08-AFC-13

RE: Calico Solar (Formerly Solar One) Project
Applicant's Submittal of Additional Information

RE: Calico Solar (Formerly Solar One) Project
Applicant's Response to Your Comments Regarding the Cadiz Supplemental Analysis

WELL LOCATION MAP
BNSF AND CADIZ WELLS
SOLAR ONE PROJECT

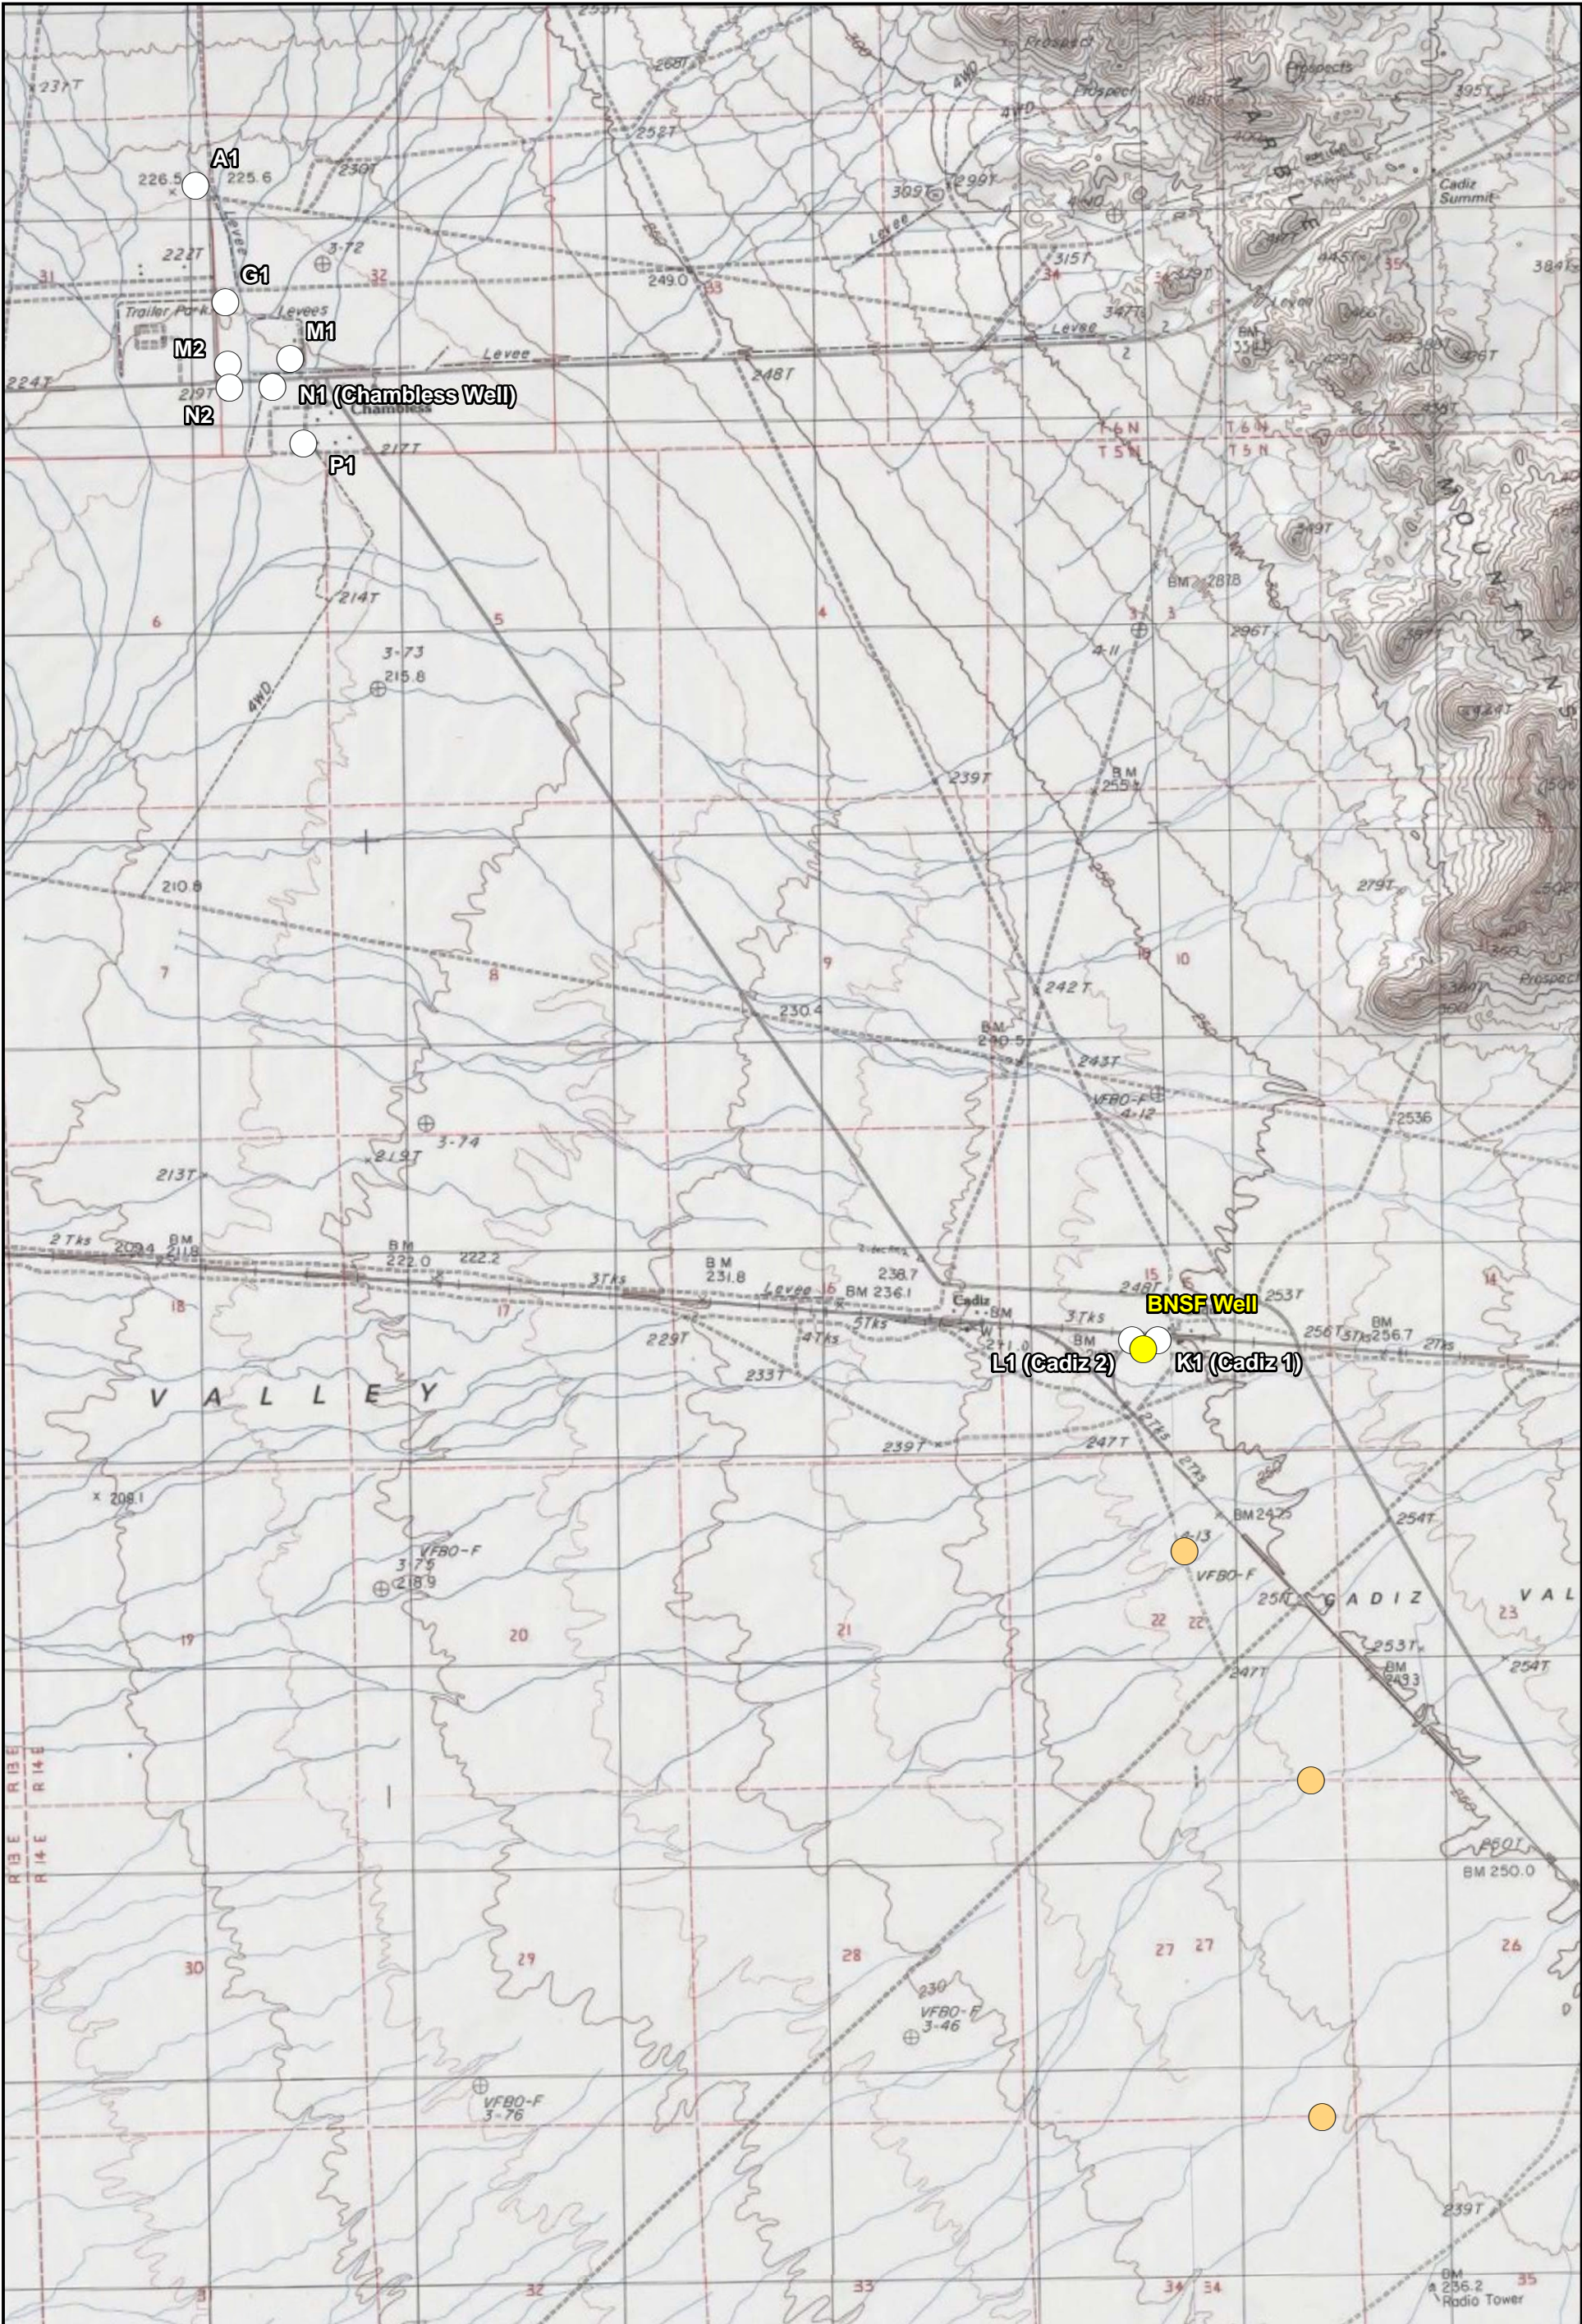
The Well Location Map has been revised to reflect the name change you requested (the well formerly labeled N1 is now N2 and the well formerly labeled N2 [Chambless Well] is now N1). The same map revision will be docketed with the California Energy Commission so that the Project record will reflect the correct names.
